Subject: Analysis of BRAC-133 Short-Term Improvements

**BRAC-133 SHORT AND MID-TERM IMPROVEMENTS
REVISED APRIL 20, 2010**

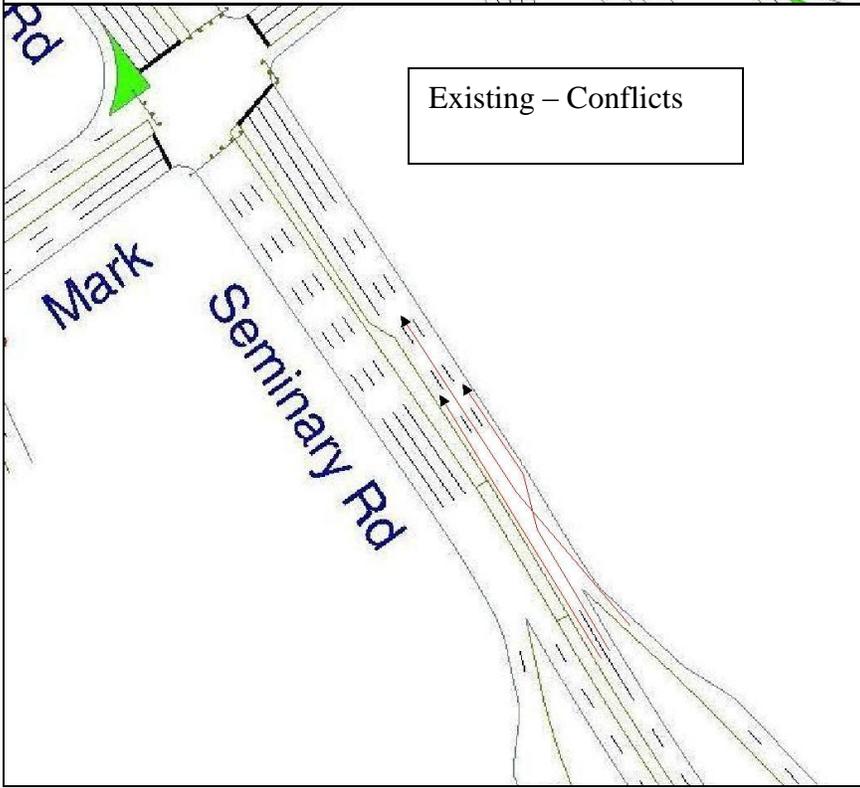
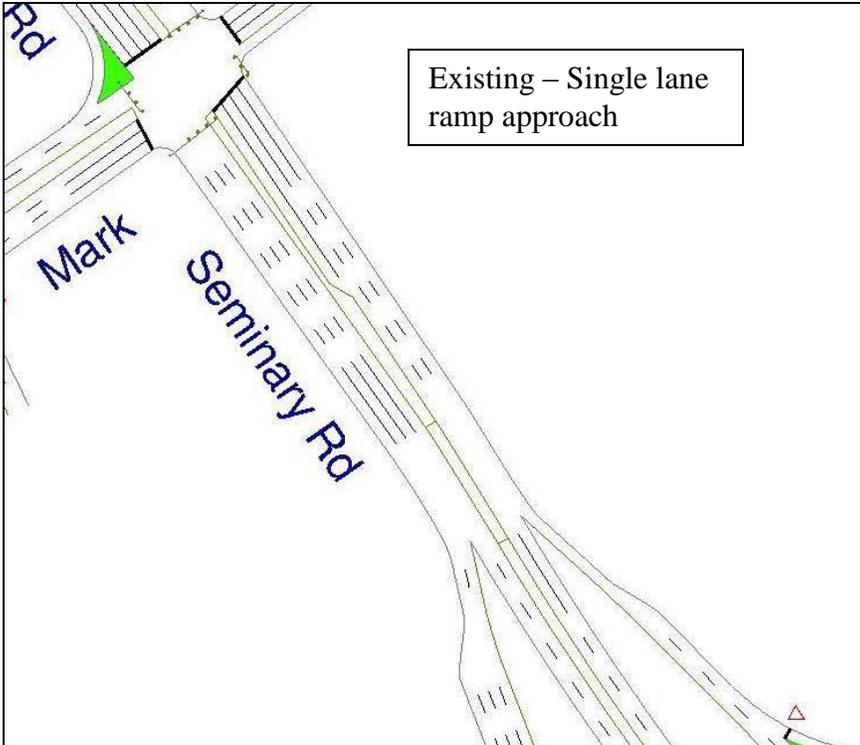
- c. Reconfigure the northbound off-ramp from I-395 to provide a right only lane and two through lanes which are cat tracked as described above. The other approaches will have at least three lanes, which channelized right-turn lanes on the eastbound, southbound, and westbound legs.

- d. These improvements will require the elimination of the island which prevents two lanes from turning left within the “traffic circle” to go westbound from the northbound off ramp.

Response: Agreed, there appears to be enough space to implement this improvement. VDOT is proposing to conduct a detailed operational analysis of this and other short-term operational improvements. City staff agrees that a detailed operational assessment should be conducted to assess the adequacy of implementing this improvement. This proposal will likely improve the Level of Service at the NB off ramp intersection, under a scenario which includes BRAC

Response: Agreed. This work will most likely require the relocation of a street light.

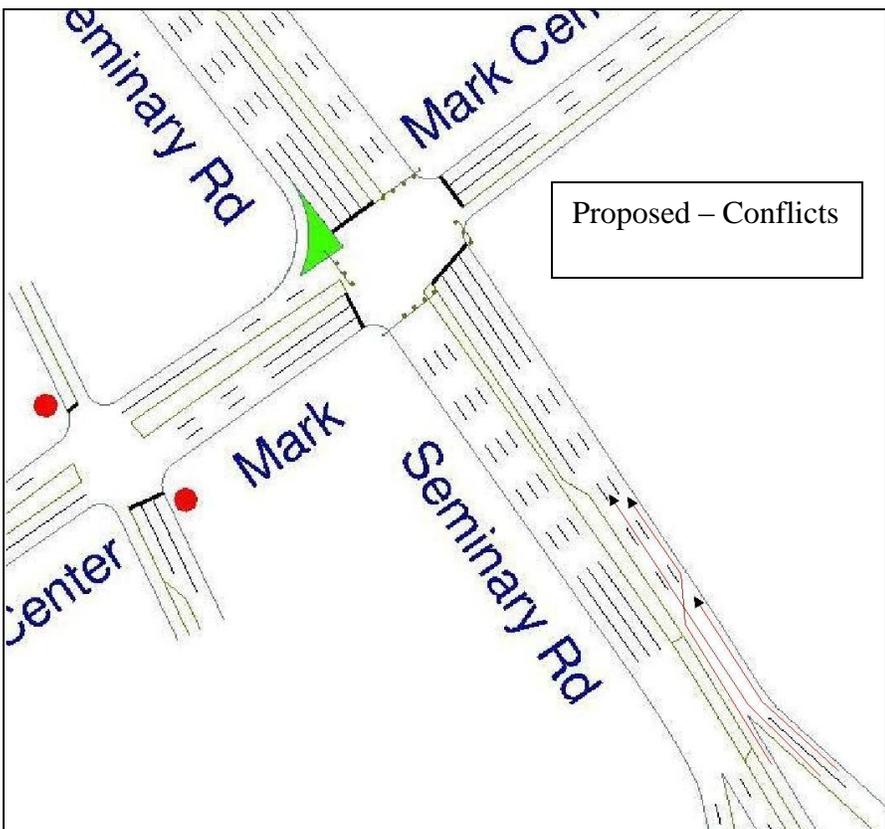
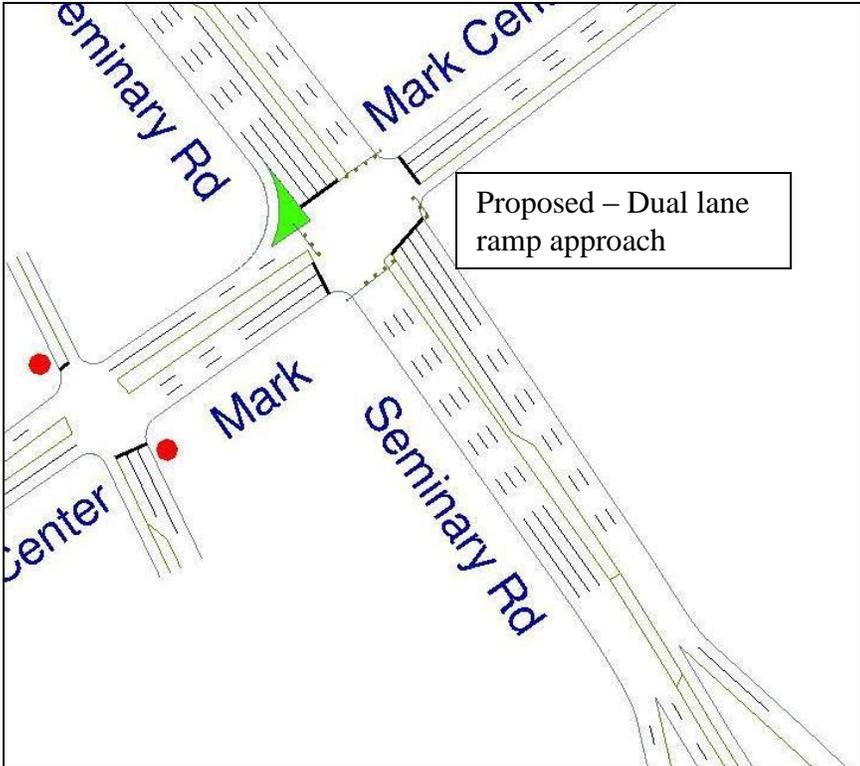
- e. Retime the traffic signals within this level of the interchange to eliminate the lost time for traffic entering the interchange from the ramps. Currently, each ramp approach into the interchange gets the green when the far signal directly in front of it also gets the green. The inside legs are universally empty, and traffic loses at least 10 seconds of saturation flow to cross the empty legs. If the signals were better timed, the approach ramp signal would turn green prior to the internal leg turning green, allowing traffic to enter and nearly fill that leg (without having to stop), eliminating the lost time. This lost time is lost capacity, and there is no safety reason to justify it.

Response: City staff does not believe that this improvement should be implemented. However, VDOT may assess this improvement in conjunction with the detailed operational analysis of short-term improvements. Capacity is not an issue for the signals within the interchange. Adjusting the signal offsets will likely not provide real benefits because traffic has not reached saturation. Under the current signal operation, all of the signal approaches within the circle provide more green time than the signal on approaches entering the circle. The signal approaches in the circle are green both before and after the approach entering the circle's green

interval. Changing the signals within the circle to turn green a few seconds later than they do today would not add capacity and may even hurt operations if there are any residual queues in the circle. Furthermore, City staff is concerned that altering the offsets may create a safety issue because of the close proximity of the traffic signals around the circle. When traffic signals are closely spaced, drivers do not always see the signal displays because their attention is focused at a farther distance.

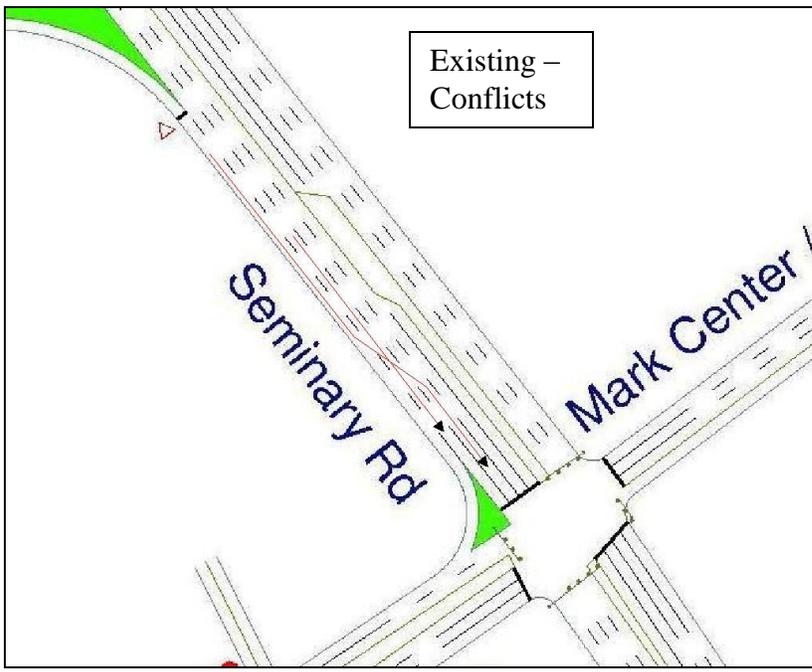
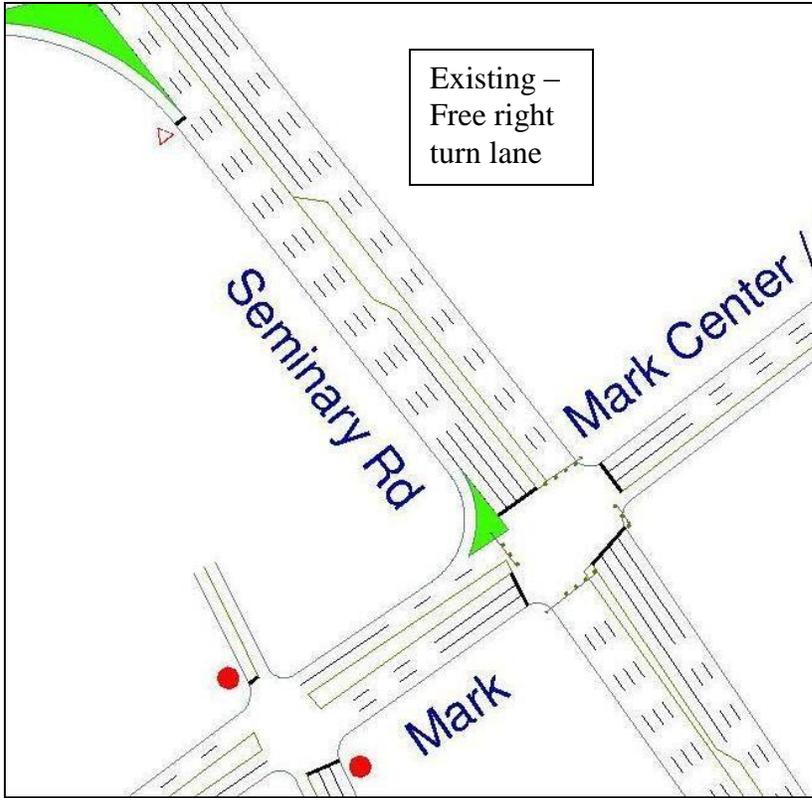
- a. Starting near the Seminary Park entrance on Seminary Road, the signing and markings need to inform/instruct the drivers as to which lanes to use to go north on I-395 or south on I-395. To make this effective, the right lane of three

eastbound through lanes on Seminary at Beauregard should be for 395 SB, the center lane for 395 NB, and the left lane for Seminary eastbound.

Response: *Agreed, signing and marking improvements will help. However, if overhead signs are needed, the cost of the signing improvements may be high.*

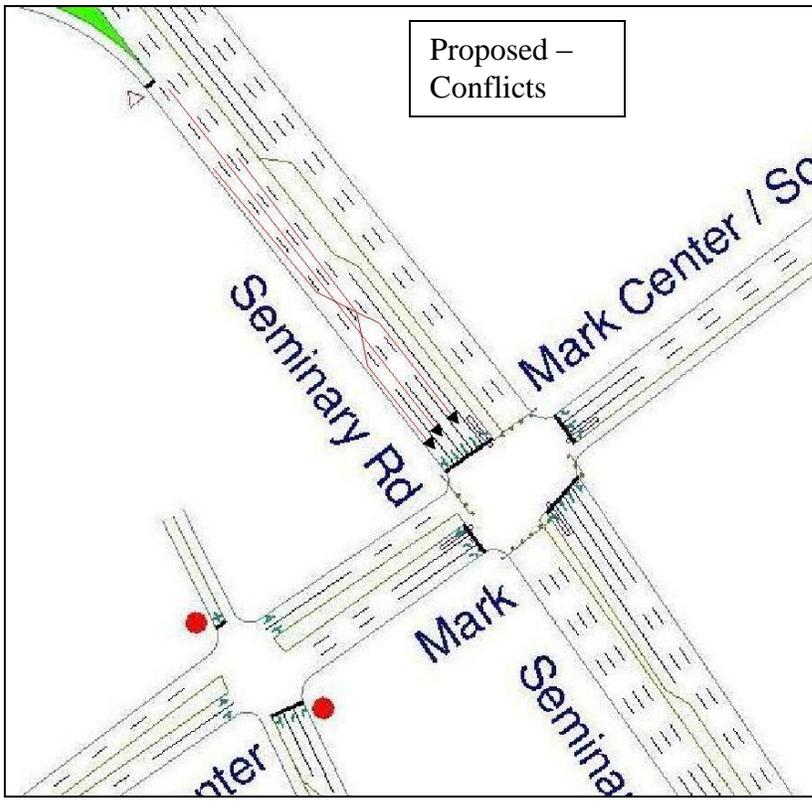
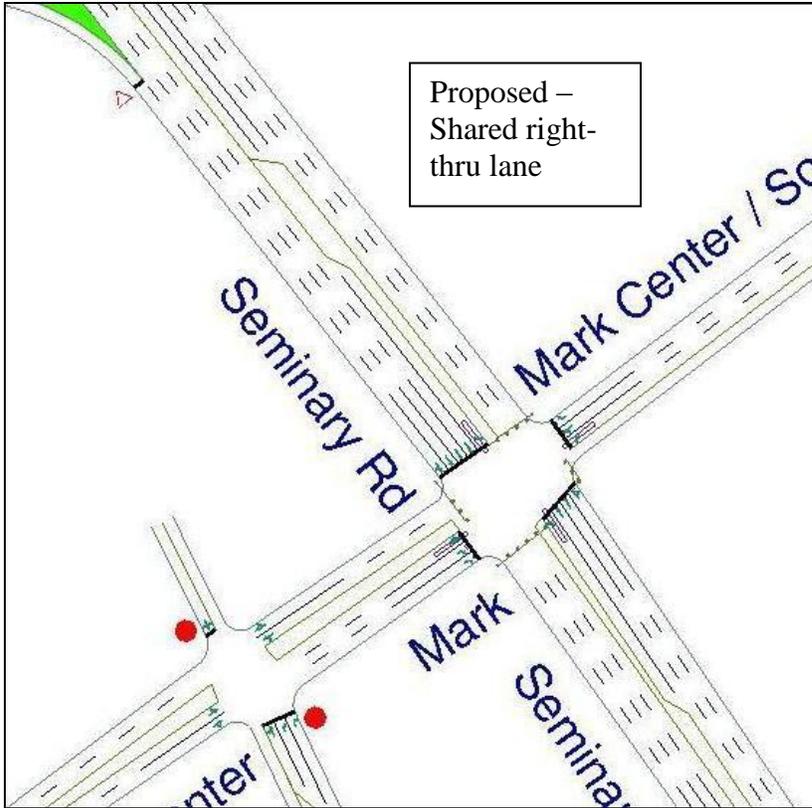
- b. Starting near the intersection of Beauregard and Mark Center drive, the signs/markings on northbound Beauregard should indicate that the right lane is 395 traffic only.

Response: *Agreed, signing and marking improvements will help. However, if overhead signs are needed, the cost of the signing improvements may be high.*
